MEMORANDUM

To: The Design Advisory Board
From: Mary O'Neil, AICP, Principal Planner
RE: ZP21-0358CA/CU; 40 Kingsland Terrace
Date: October 27, 2020, November 24, 2020, **February 23, 2021**

File: ZP21-0358CA/CU

Request: Demolish existing garage; construct new **660 sf. garage** with Accessory Dwelling Unit (ADU.)

Principal structure, 40 Kingsland Terrace

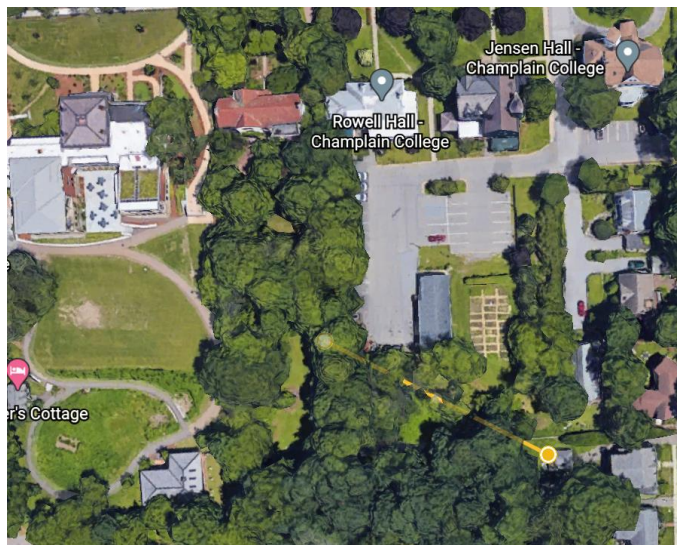
The proposed **gable** roofed building is larger than the existing garage it proposes to replace. The location behind the single family home and at the end of a dead-end street reduces the visual impacts of the larger structure.

The **gable** roof with **dual shed** dormers **reflects a different style from the earlier submission, but is consistent with some garage types.**

Windows are either double hung or **transom** with muntin patterns recalling the principal home. The garage doors look to resemble paired carriage house doors.
